ADDENDUM #4

Tender No. ENG 25-04 – Uganda Pump Station Upgrades

Please note the following Clarifications, Questions and Answers for the above noted Tender is to be known as Addendum #4. Bidders are to reference receipt of Addendum #4 in their submission.

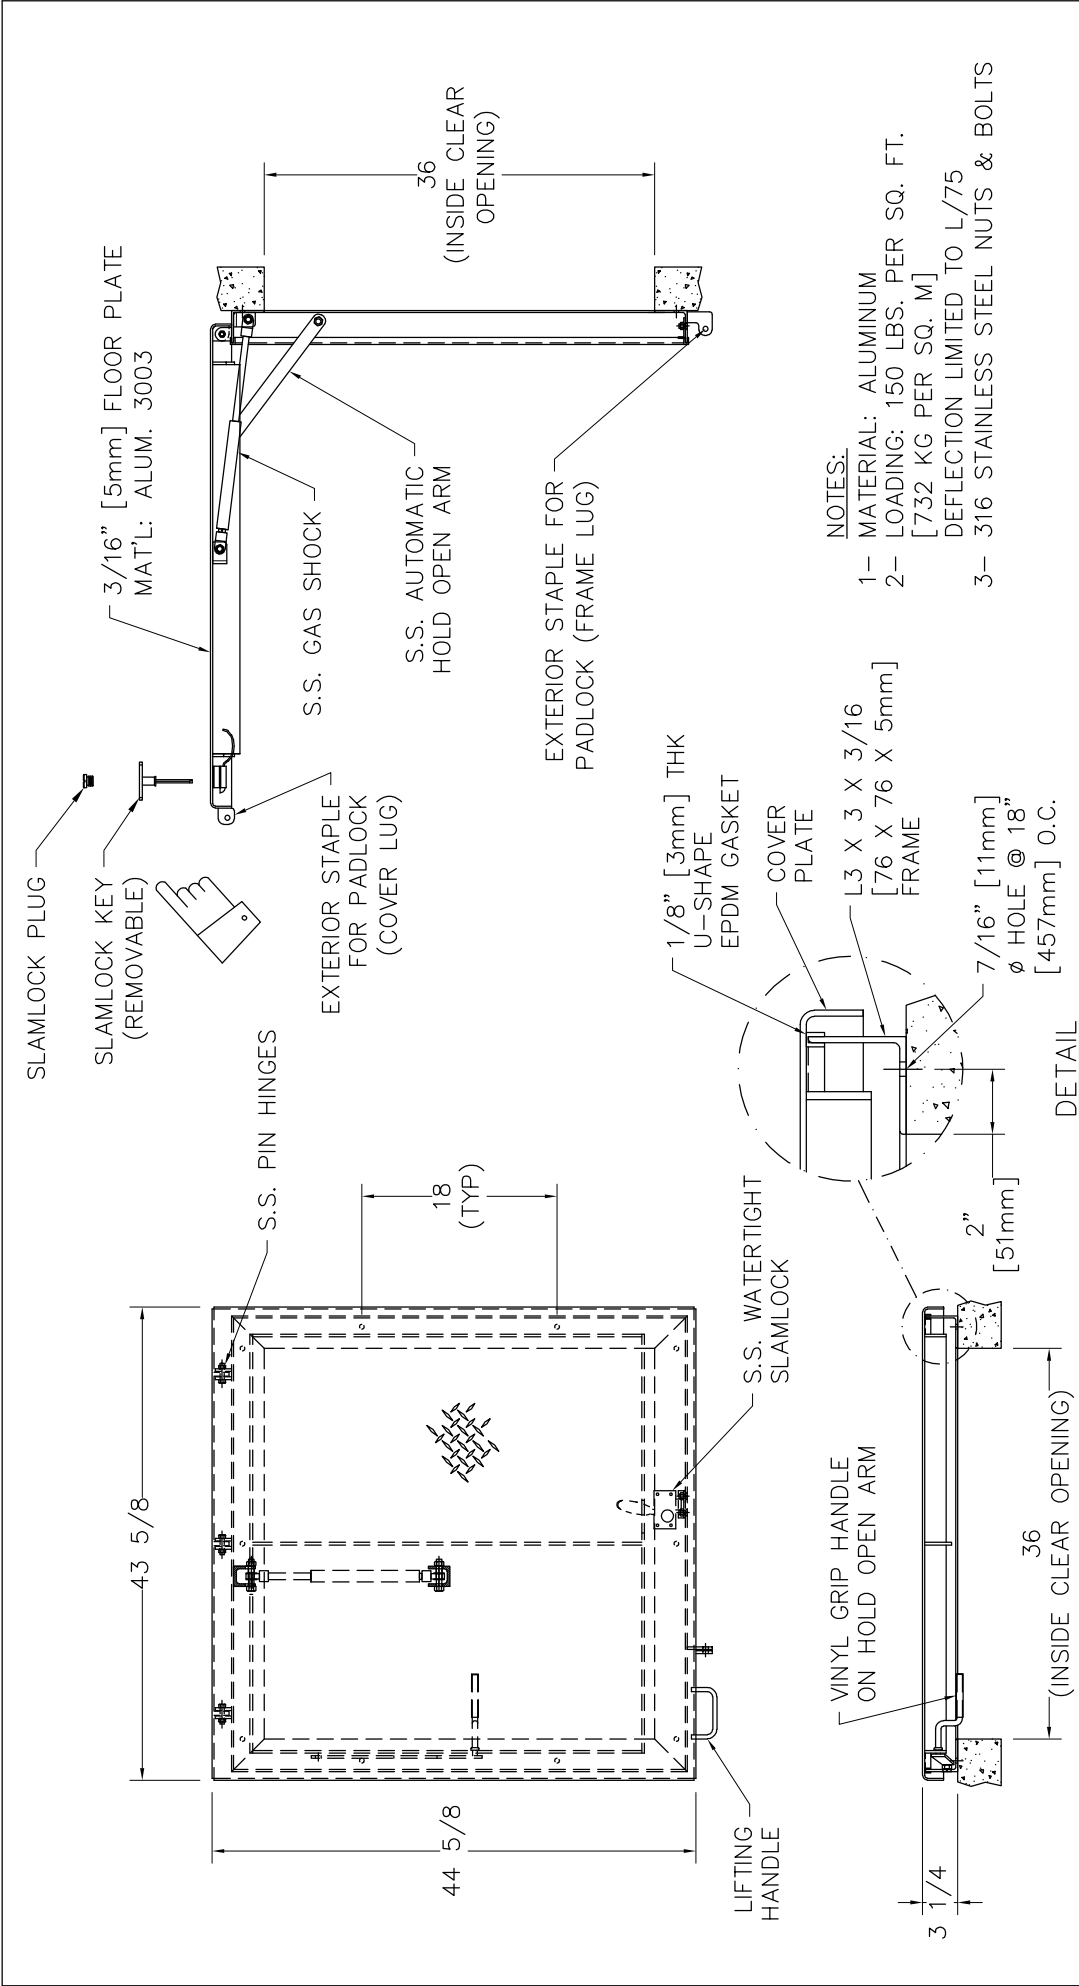
- The previously referenced Flygt Safe-Hatch is discontinued and no longer available.
- Suitable products by USF, MSU or EJCO are acceptable, subject to shop drawing approval
- A USF SRR-I 36" × 36" or similar model will be acceptable, subject to shop drawing review. The design calls for combining two rough openings, which may result in a new opening of approximately 1.52 m × 0.99 m. Contractor to confirm exact measurements prior to construction.
